# 2401 NW MARKET ST

DESIGN REVIEW - 3039108-LU

SEPTEMBER 18TH, 2023

## 1.B) BUILDING MODULATION & MATERIALS

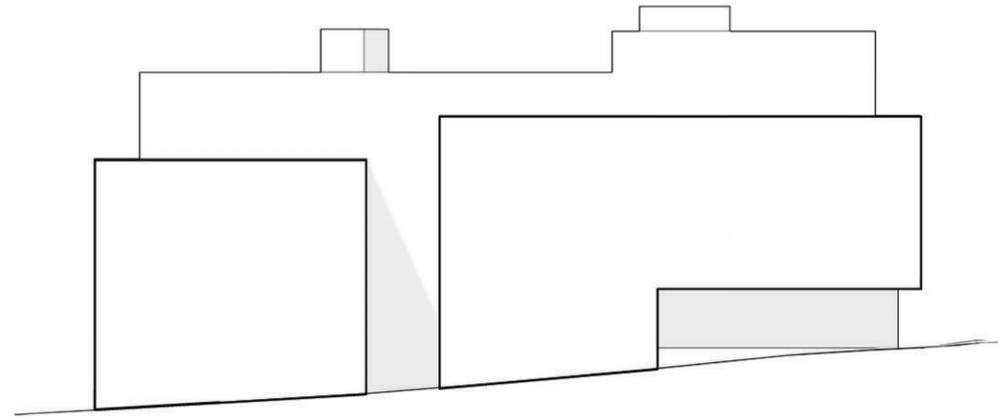
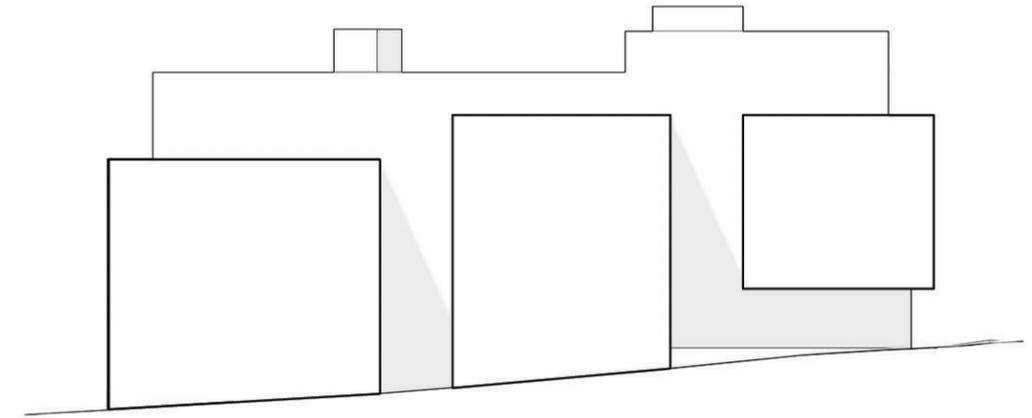
ALONG 24TH AVE NW THE BOARD RECOMMENDED

- RECESSES
- PLANE CHANGES
- MATERIAL CHANGES

ALONG 24TH WE HAVE

- ADDED ADDITIONAL MODULATION TO DEFINE THE CORNER MASS
- SELECTED/PLACED MATERIALS TO CREATE CONTRAST

## 2.B) CORNER RETAIL SETBACK

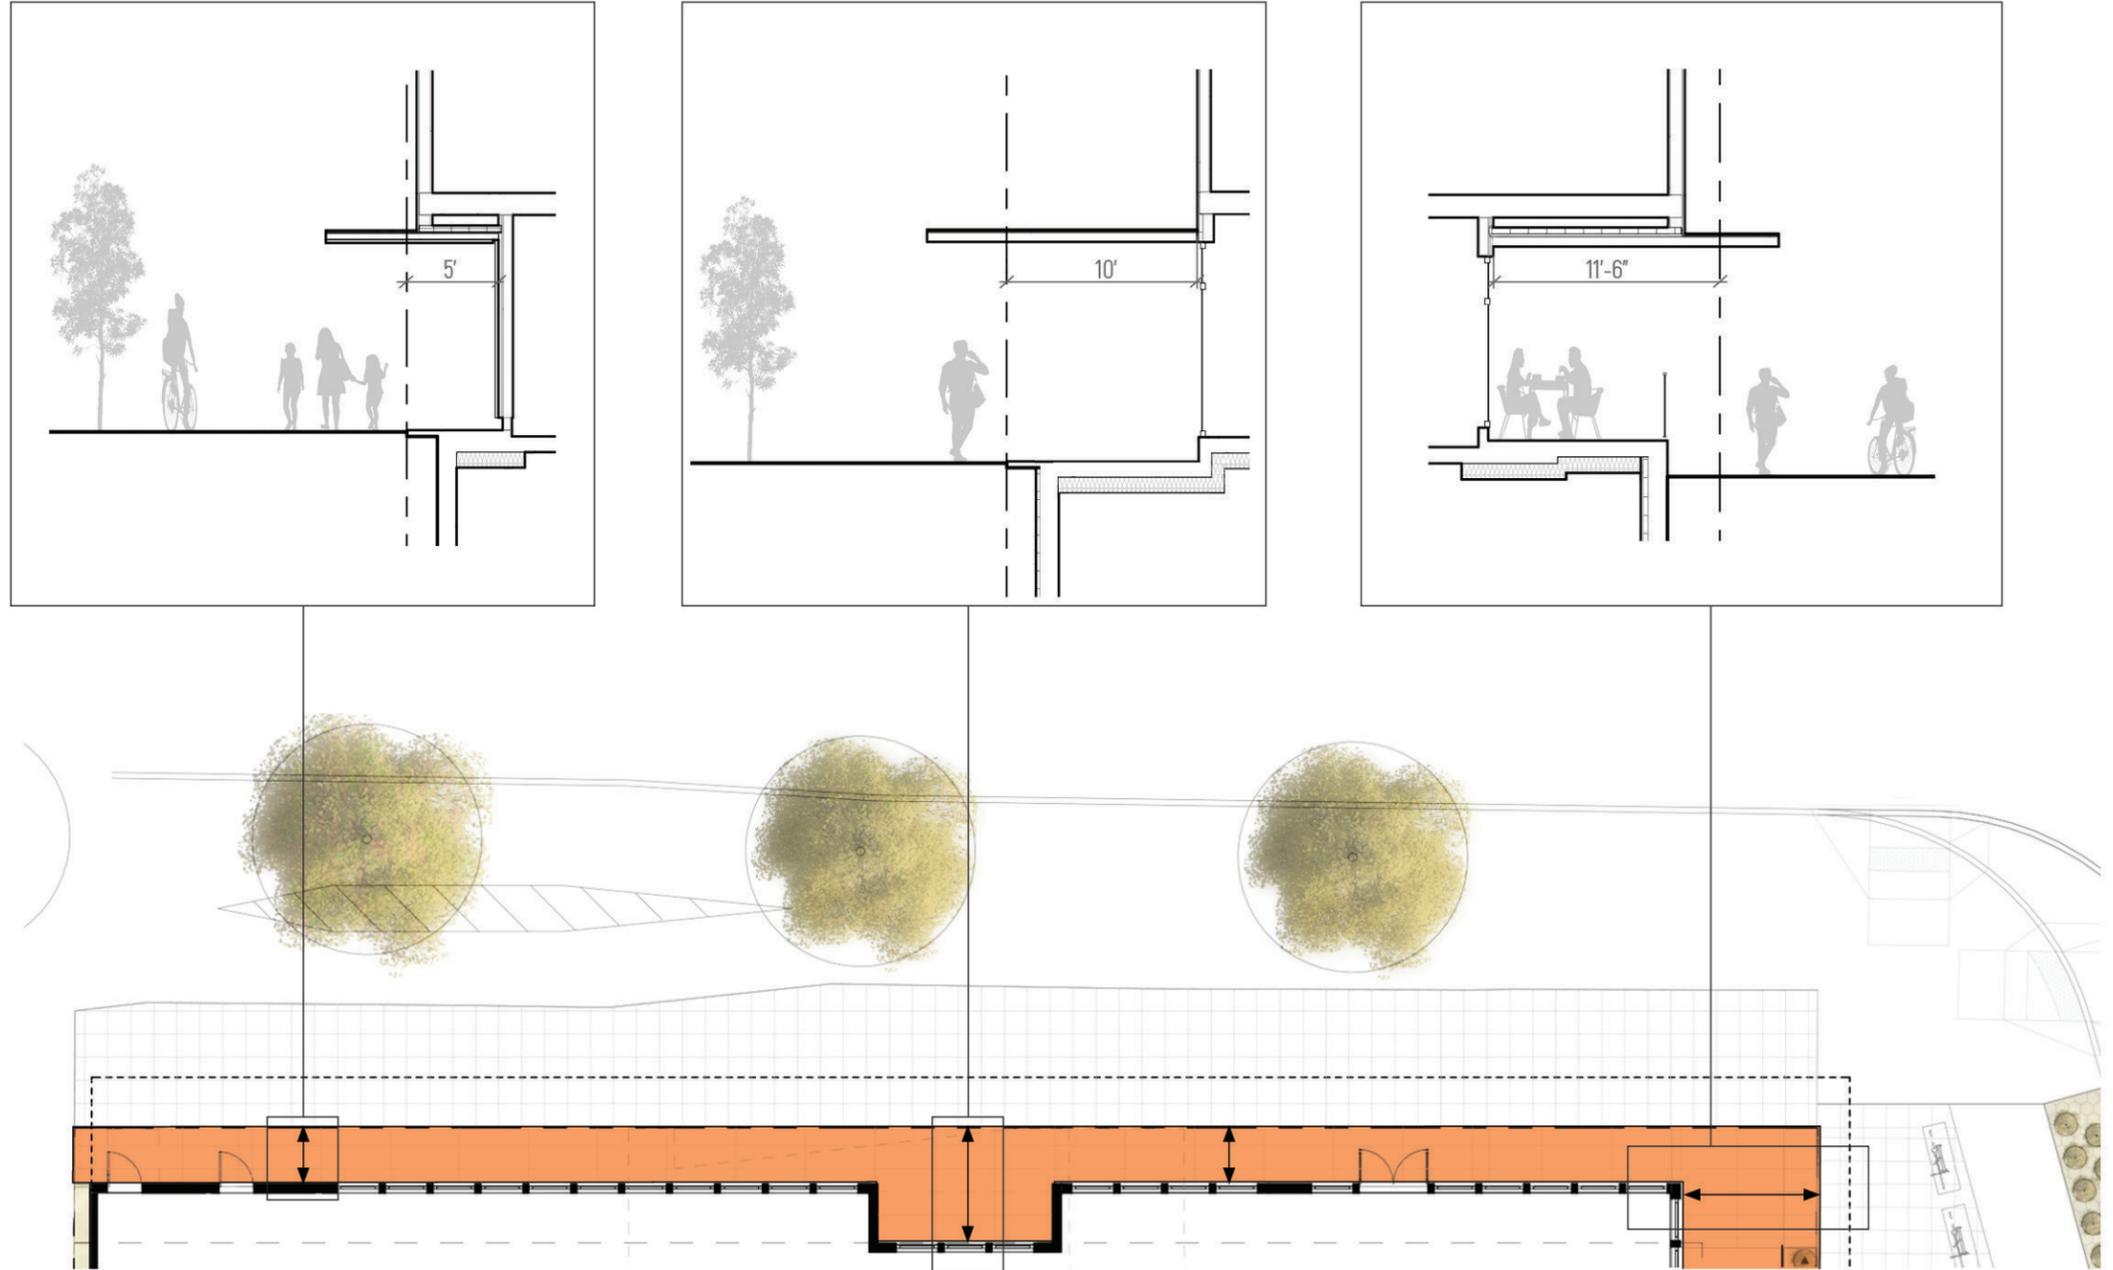
### THE BOARD SUPPORTED

- ESTABLISHING A RETAIL SPACE AT THE CORNER
- INCREASED SETBACKS AT THE STREET LEVEL

### THE BOARD NOTED THE SETBACKS

- ALLOW THE SIDEWALK TO CREATE ACTIVE SPACES
- PROVIDE RELIEF AT THE STREET LEVEL
- PROVIDE ADDITIONAL SPACE ALONG THE BURKE GILMAN TRAIL

- WE ARE IN AGREEMENT WITH THE BOARDS OPINIONS
- WE HAVE DEVELOPED THIS AREA AS A KEY DESIGN FEATURE

## 3.A & 3.B) RESIDENTIAL LOBBY ENTRY

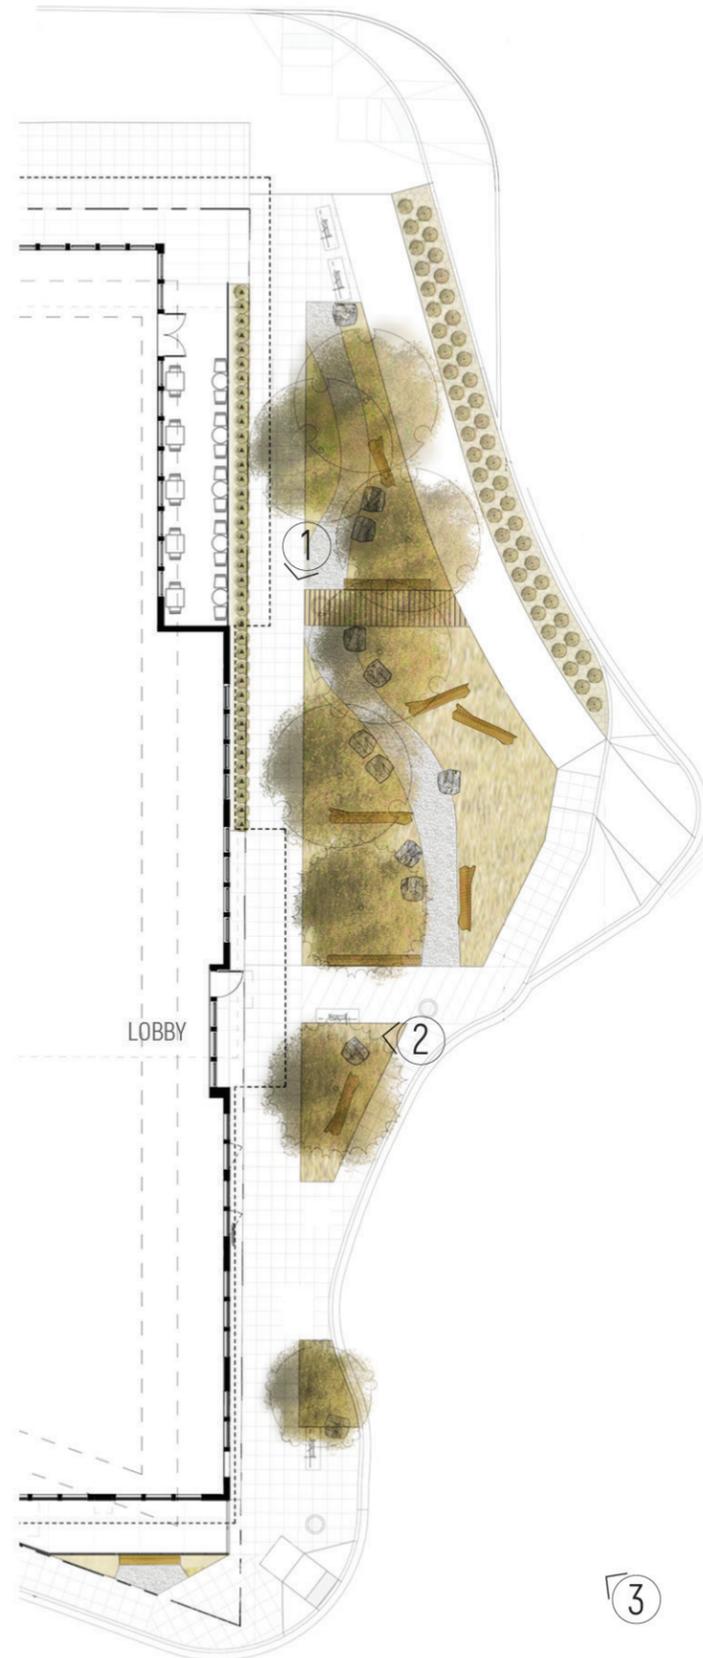
- SUPPORTED THE RESIDENTIAL LOBBY
- NOTED ITS LOCATION APPROPRIATELY RESPONDS TO THE CONTEXT
- RECOMMENDED FURTHER DEFINING THE RESIDENTIAL LOBBY TO ASSIST IN WAY-FINDING

#### WE HAVE INTRODUCED SEVERAL KEY DEFINING FEATURES

- A SPACIOUS CANOPY
- PROMINENT SIGNAGE
- EXTENSIVE GLAZING

## 3.C) STREET LEVEL CORNER UNITS

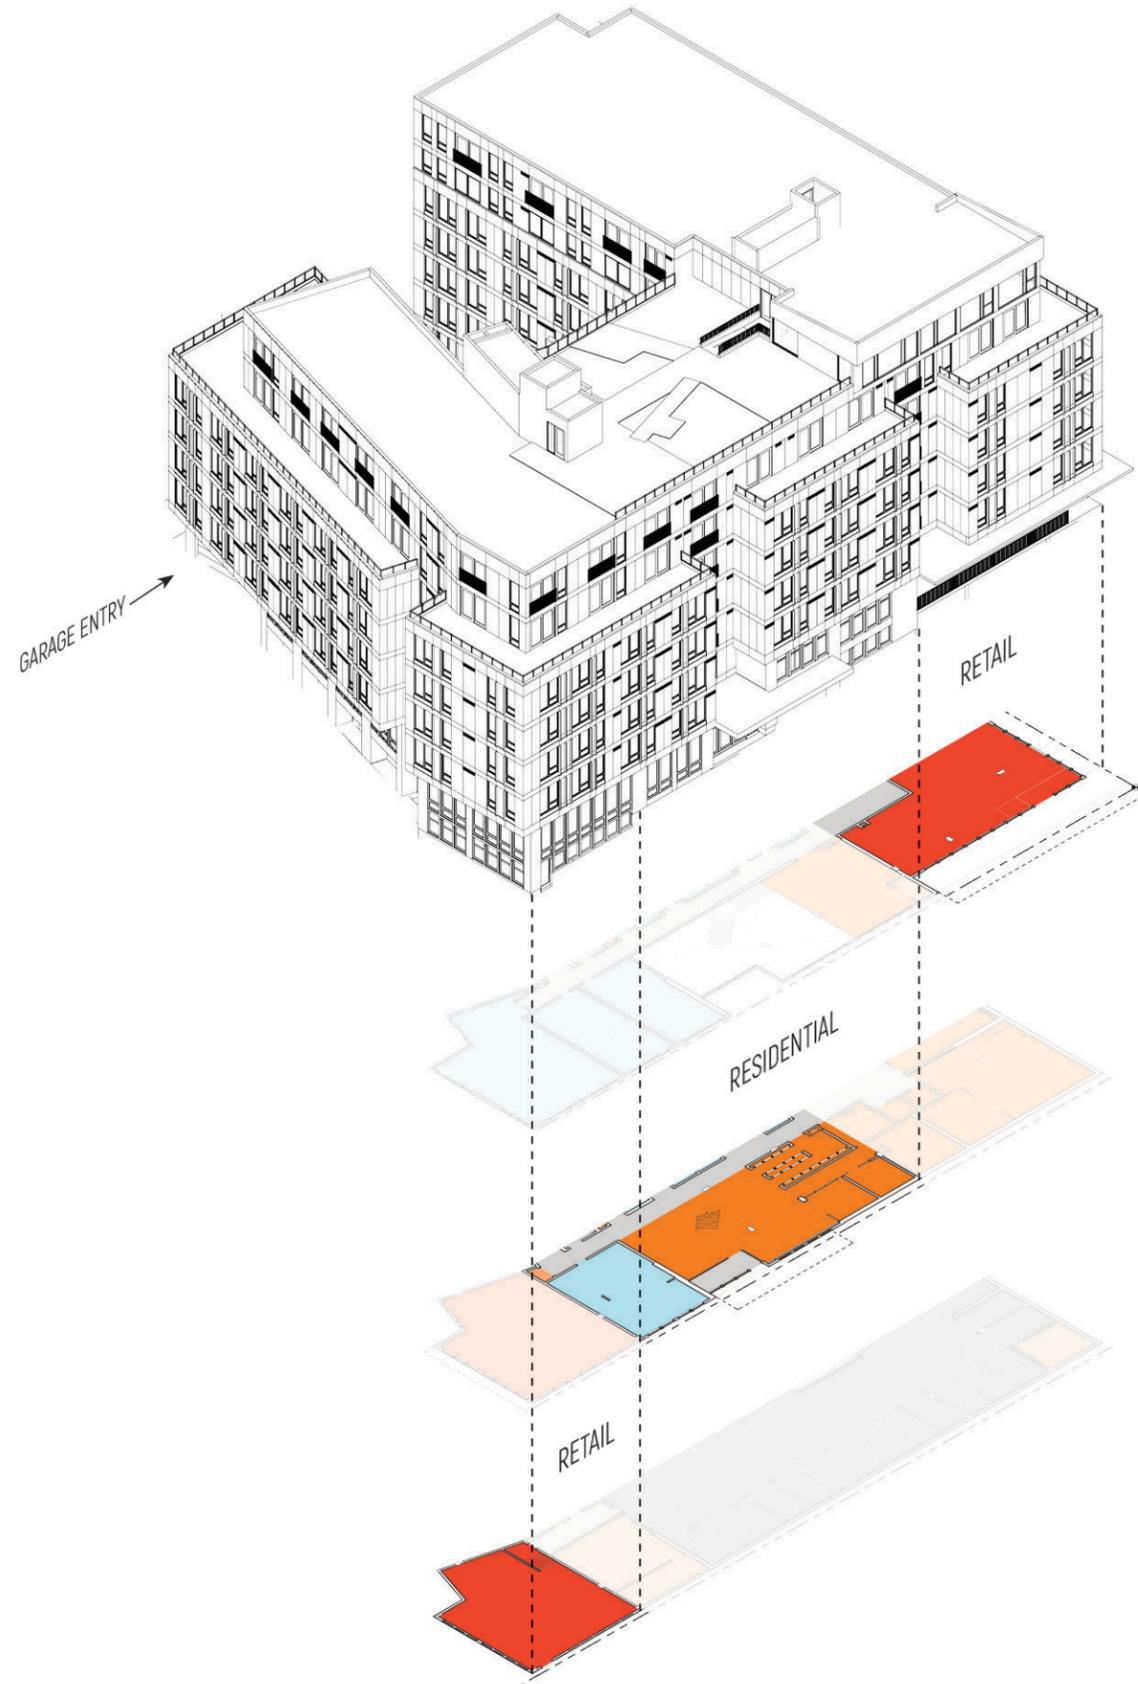
THE BOARD EXPRESSED CONCERN WITH THE PRIVACY AND ENTRY INTO THE RESIDENTIAL UNITS AT THE SOUTHEAST CORNER OF THE SITE.

THE CORNER UNITS ARE NO LONGER INCLUDED IN THE DESIGN.

## 3.E) SITE BENCHES

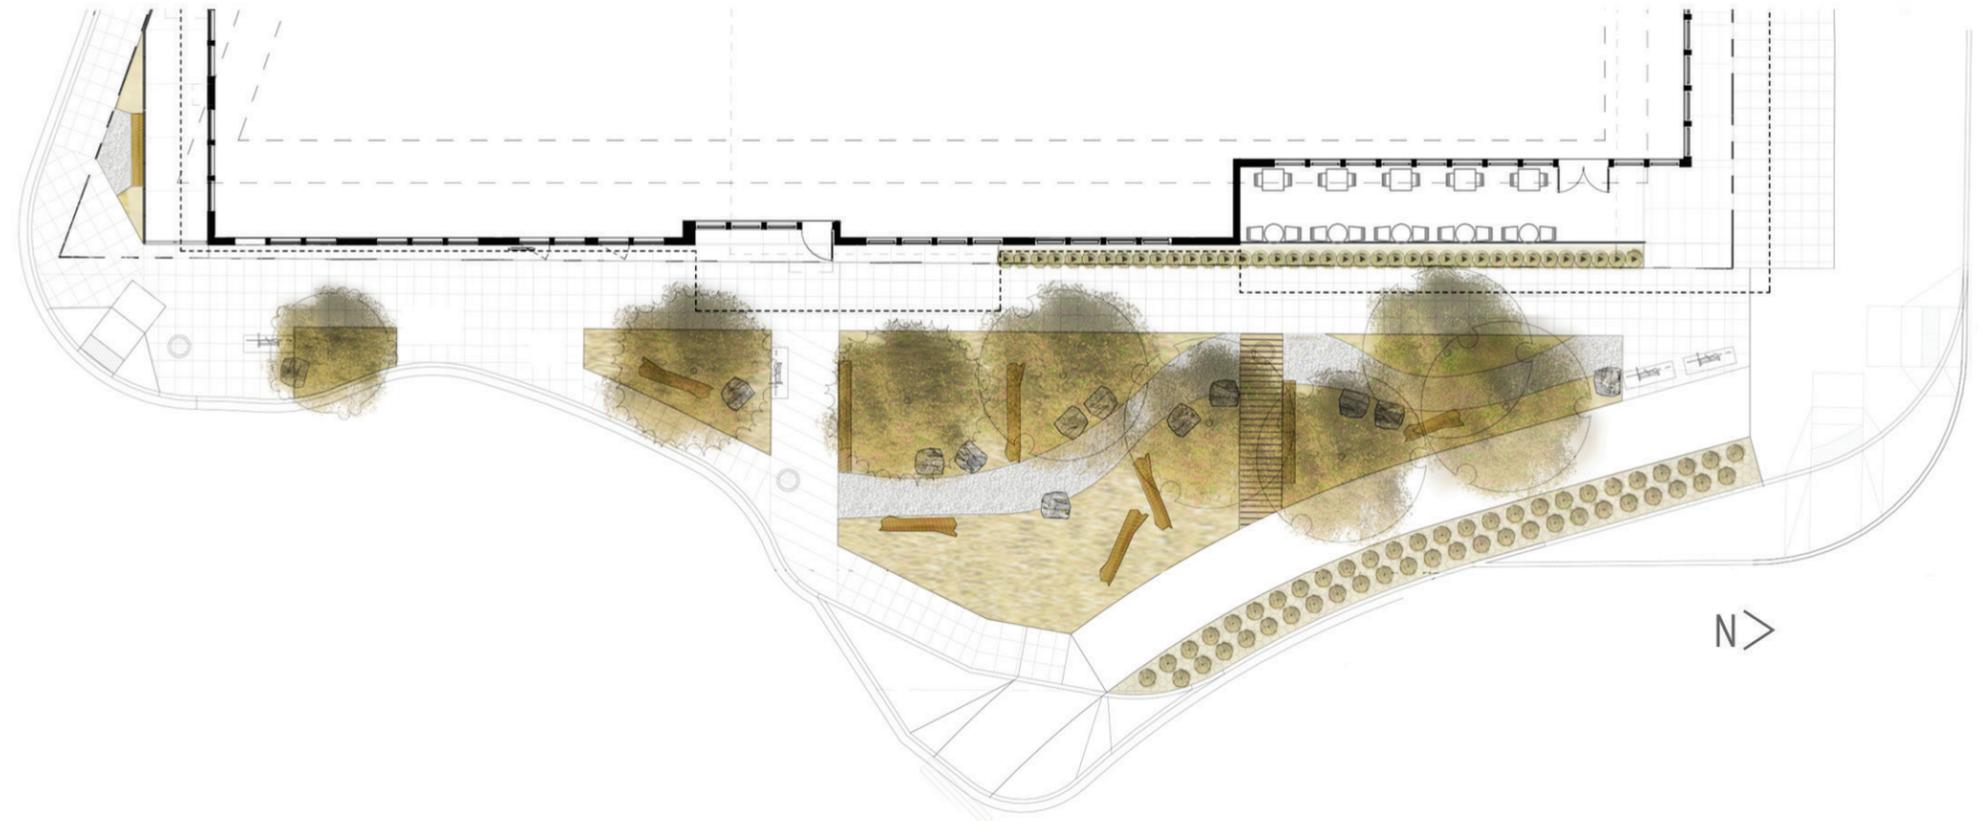
- SUPPORTED THE DIRECTION OF THE SITE LANDSCAPING
- RECOMMENDED THE LANDSCAPING "BULB" BETWEEN THE TRAIL AND SIDEWALK INCLUDE ELEMENTS TO CALL ATTENTION TO THE SPACE
- EXPRESSED CONCERN THAT THE GRADE MAY NOT BE VIABLE TO PERMIT THE BENCHES SHOWN IN THE PLANS

- THE LANDSCAPING IN THE "BULB" INCLUDES COLORFUL PLANTS THAT NOD TO THE NORDIC HERITAGE OF BALLARD, AS WELL AS SEATING AND CIRCULATION PATHS SO THAT PEOPLE MAY MOVE THROUGH AND OCCUPY THE SPACE.
- THE BENCHES HAVE BEEN SIZED AND ORIENTED TO WORK WITH THE GRADING ON THE SITE

## 4.A) MATERIALS

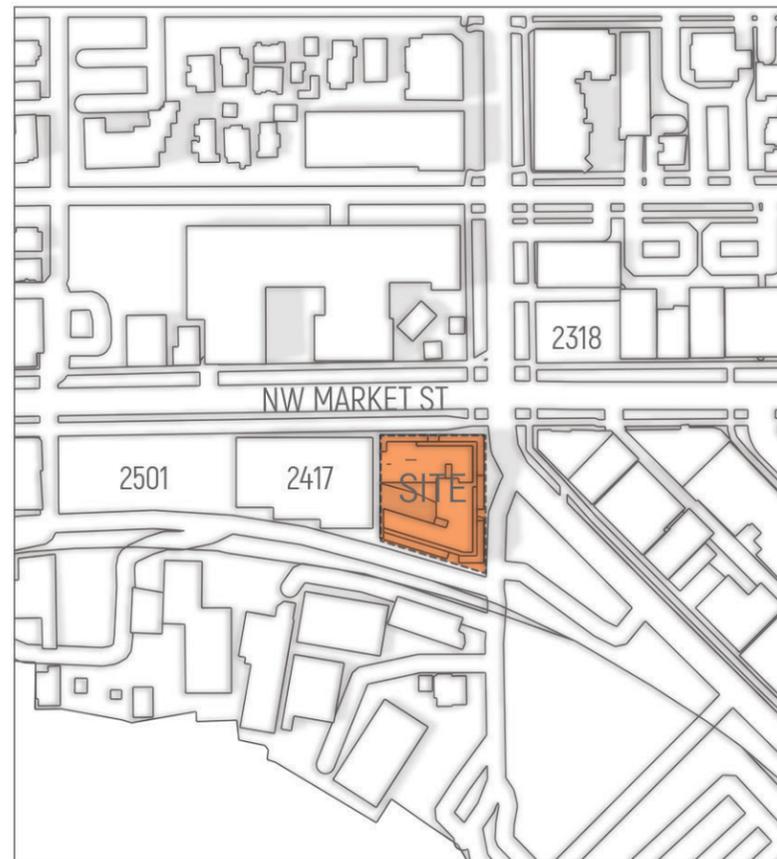
THE BOARD SUPPORTED MATERIALS THAT WOULD

- CALL ATTENTION TO THE GATEWAY CORNER
- ALLOW THE BUILDING TO BE VIEWED AS PART OF AN ENSEMBLE

WE HAVE

- REVIEWED THE NEIGHBORING BUILDINGS MATERIALS
- USED SIMILAR MATERIALS WITH SOME COLOR VARIATION
- USED MATERIALS THAT WILL ALLOW THE BUILDING TO BE VIEWED AS PART OF AN ENSEMBLE
